SUBJECT: Town of Huntington
Suffolk County, NY
Contract Documents and Specifications
Contract No. ENV94-01/0-C
Interim Remedial Program
Huntington/East Northport Landfill
Addendum No. 1

ADDENDUM NO. 1

Addendum No. 2

Huntington/East Northport Landfill		
Contract No. ENV 94-01/O-C		
Addendum No. 3	REF. DWG.	C-22
REPLACES SK-C6	SHEET	SK-C23

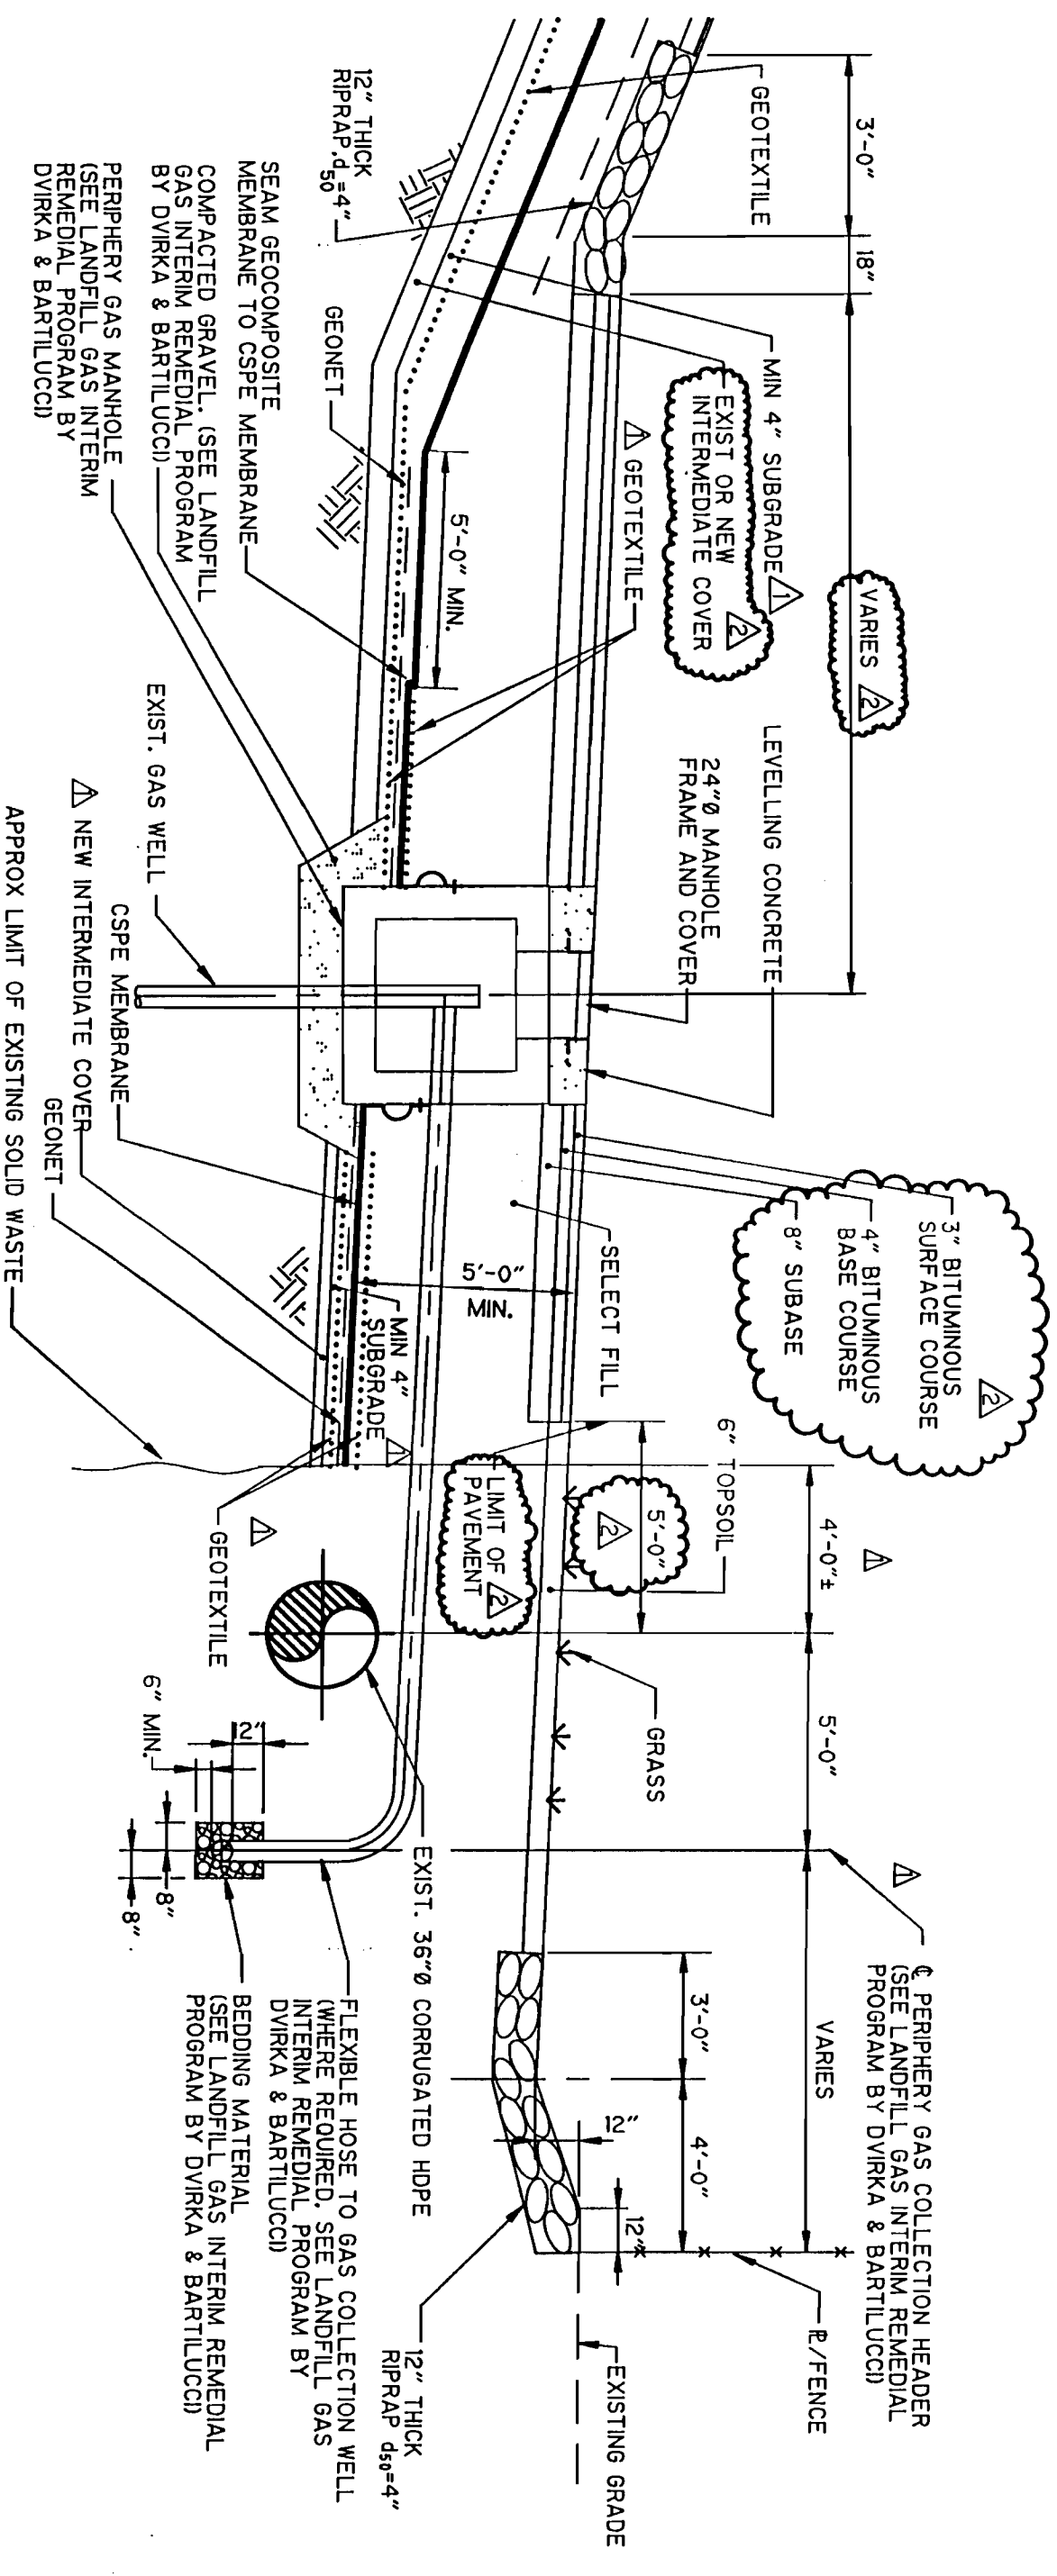
C-22	1. Typical Toe of Landfill Detail for Sections 12 and 10 East (At Catch Basin). Revise as indicated in SK-C6. 2. Typical Toe of Landfill Detail for Sections 20, 21, and 22 East (At Gas Manholes). Revise as indicated in SK-C7. 3. Typical Toe of Landfill Detail for Sections 20, 21, and 22 East (No Gas Manholes). Revise as indicated in SK-C8. 4. Typical Toe of Landfill Detail for Sections 9 and 9A (At Gas Manholes). Revise as indicated in SK-C9. 5. Typical Toe of Landfill Detail for Sections 1, 2 and 3 North. Revise as indicated in SK-C10. 6. Typical Headwall Detail and Recharge Basins. Revise as indicated in SK-C 11A and SK-C11B.

D) CONTRACT DRAWING 6 OF 16

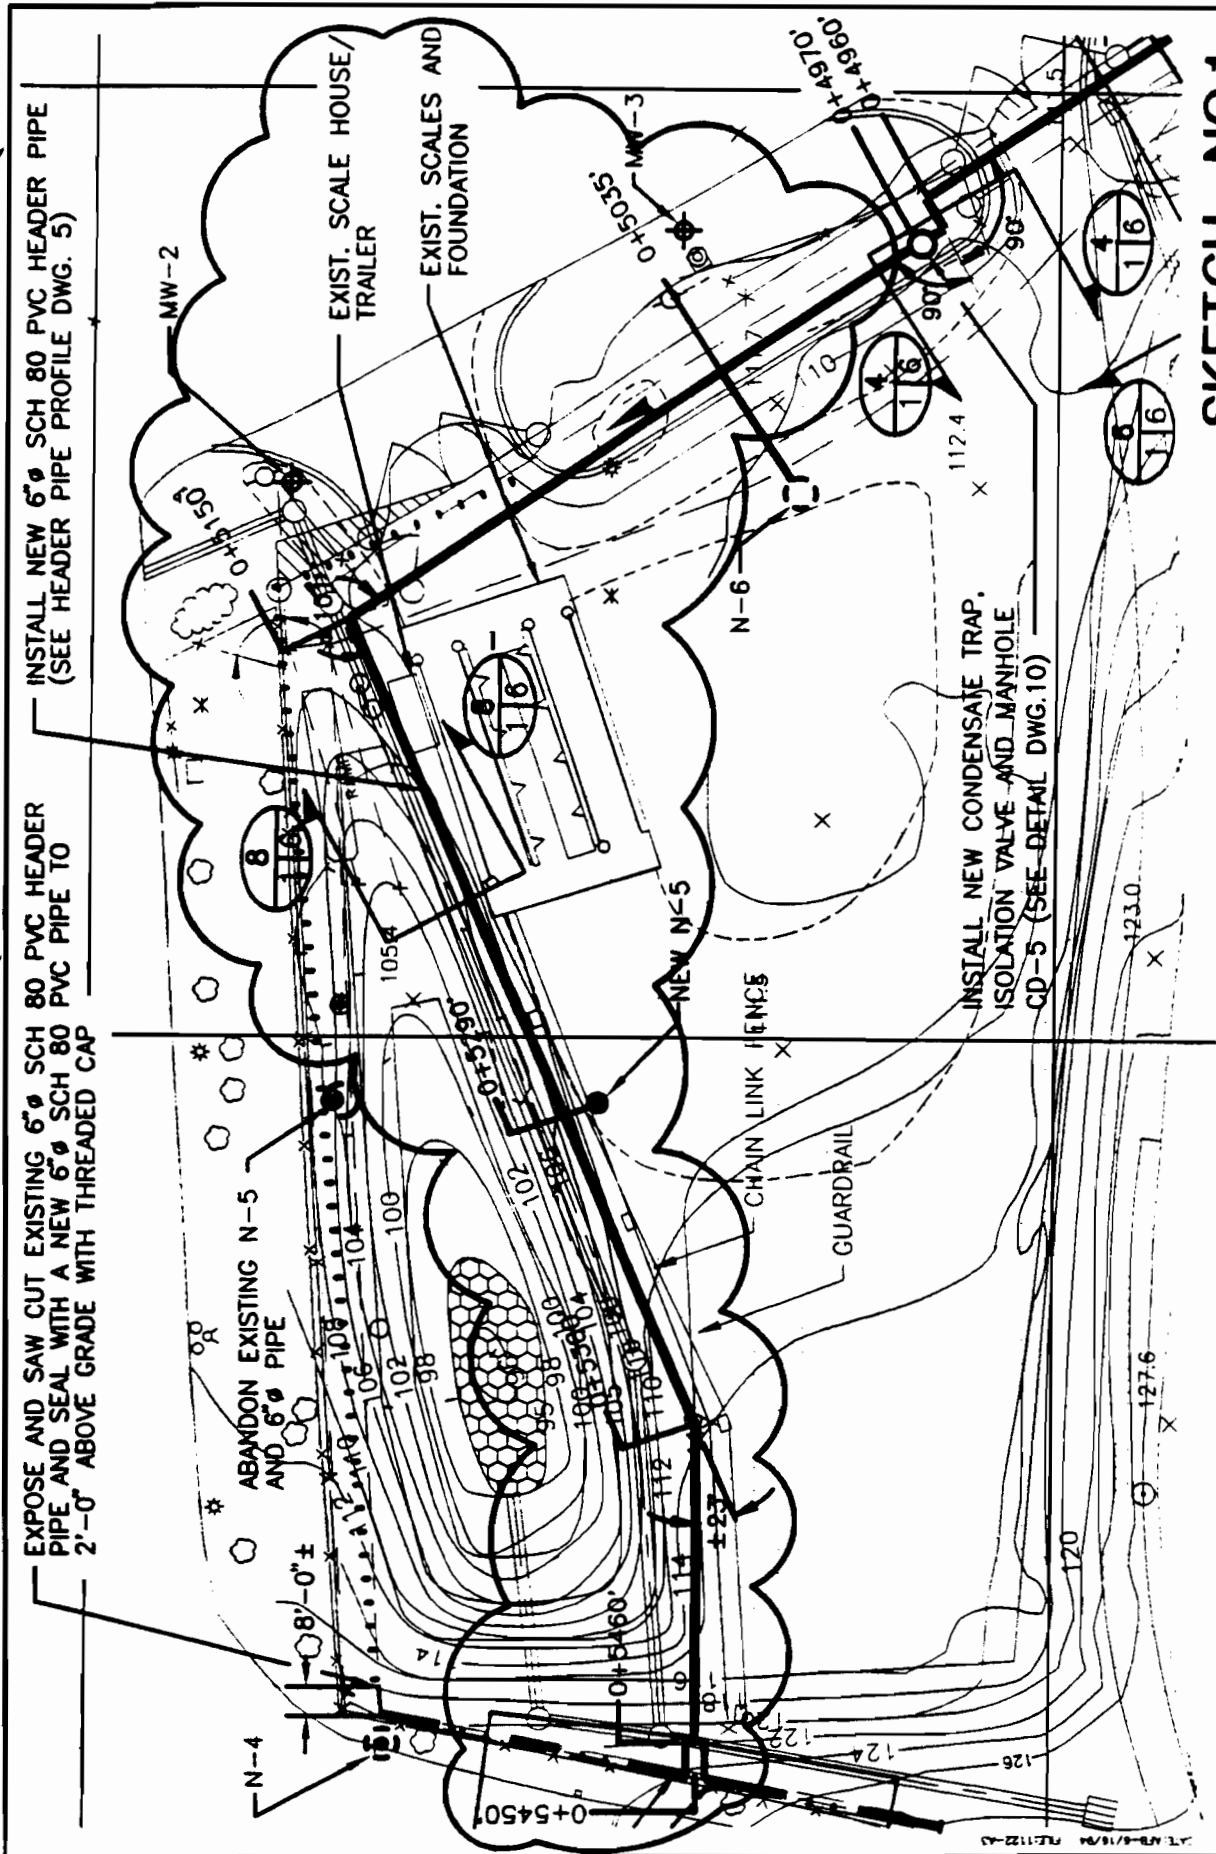
1. Add new detail "HEADER PIPE SECTION 8" as shown on attached Sketch No. 3.
